intel® Technical Advisory

TA-669-3

Intel® Server Chassis SC5200 SAF-TE Controller Crystal Operating Outside Design Specifications

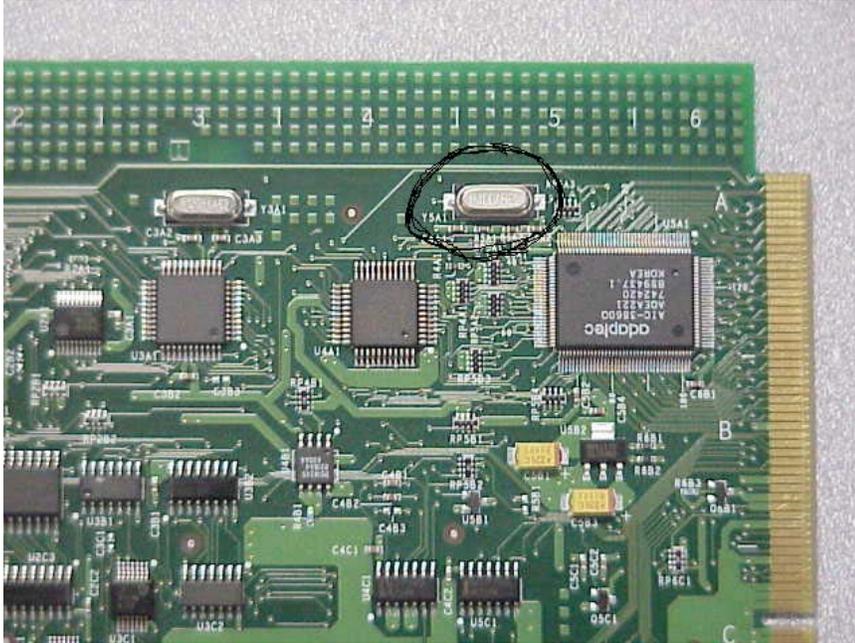
- Product built between June 30, 2003 (WW~~27~~) and September 5, 2003 (WW~~36~~)
- Product bearing the Serial Numbers: IMJR3~~27~~XXXXXX through IMJR3~~36~~XXXXXX
 - Decode Mechanism is: First Digit=Year=2003, Second and Third digits=Work-Week, X=Don't Care (DC)
- Crystal in location Y5A1 on the SAF-TE card is marked with “40.0[N] XXXX”

- Product built **before** June 30, 2003 (Serial #: IMJR3~~26~~XXXXXX) **OR** **after** September 5, 2003 (Serial #: IMJR3~~37~~XXXXXX)
- System configuration is SCSI only (i.e., use SCSI drives in “non-RAID” configurations only)
- System configuration is a non-SAF-TE RAID
- Crystal in location Y5A1 on the SAF-TE card is marked with “R400 XXXX”

The SAF-TE card design specifications require the use of a crystal with fundamental frequency (f0) of 40.0 MHz. However, the failing SAF-TE cards (supplied by a single-vendor) were determined to have been built with 3rd overtone (3f0=3*13.3MHz) crystals.

1. Remove hot swap drive bay from the Intel Server Chassis SC5200 chassis (for chassis products).
2. Remove the white plastic piece (part number 743492-004) attached to the hot swap backplane bay with four screws.
3. Remove the hot swap backplane board and the attached SAFTE card from the hot swap backplane bay.
4. Find the crystal (silver colored) at location Y5A1 on the SAFTE card (PBA A42862-110). The crystal location is shown in the photograph below.
5. Crystals marked with "R400 XXXX" are NOT affected by this issue. Crystals marked with "40.0 [N] XXXX" are affected by this issue. The XXXX markings are date-code related and should be considered as don't cares for the "crystal" issue

- All existing inventory is being screened for the “crystal” issue.
- A light-colored sticker has been added on the shipping box for Intel® Server Chassis SC5200 products and accessory kits with serial number work-weeks between 27 and 36 that have already been screened by Intel for this issue.
- All new SAF-TE cards are now being built with the f0=40MHz crystals (supplied by a different vendor)
